**Product Bulletin:** Variable Power Divider System

**Type:** Notice

**Products Impacted:** ALL Schwarze Single Engine A7, A8, and A9 Sweepers equipped with the Marmon-Herrington Variable Power Divider System (VPD)

**Condition:** The Marmon-Herrington VPD has the potential to overheat due to insufficient cooling in some applications

2. Fuse Location:

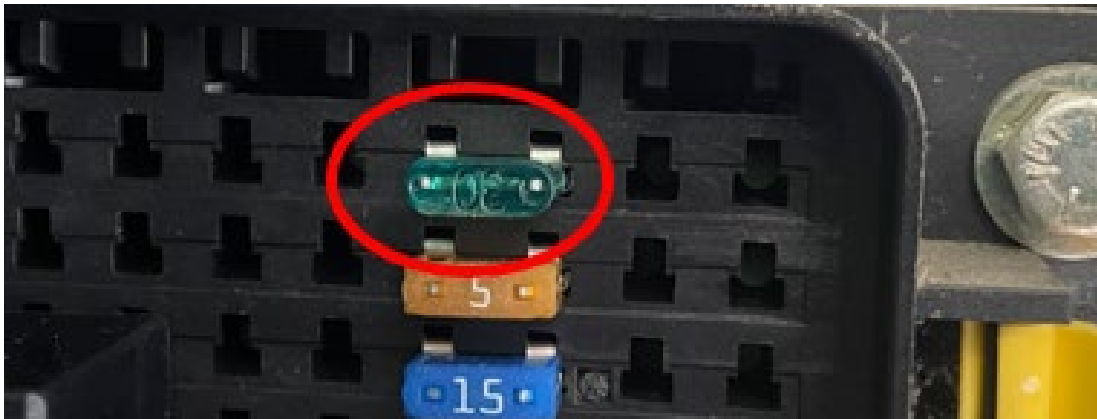
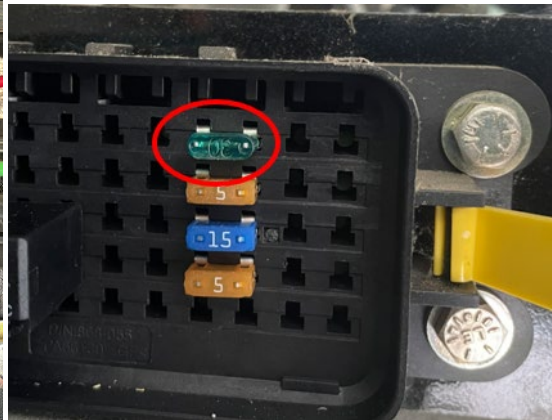
1. Check the VPD cooling fan circuit for the fuse condition. The current fuse is a 30-amp fuse and must remain a 30-amp fuse until the forthcoming update is installed.
  - If the fuse is blown it must be replaced with a 30-amp fuse (to be supplied by Marmon-Herrington).
  - See below for fuse block location.
2. Confirm function of the VPD cooling fan per section 5.3.2 of the VPD operator's manual (MM3VPD Operator's manual attached)
  - If the fuse is in working condition and the fan is not working, the wiring must be checked for continuity or damage.
  - See below for fan function check procedure.
3. Until the auxiliary warning system update is installed, the sweeper console must remain on whenever the chassis is on to ensure any broadcast VPD error messages can be received by the operator/driver. This includes when only transporting the unit.
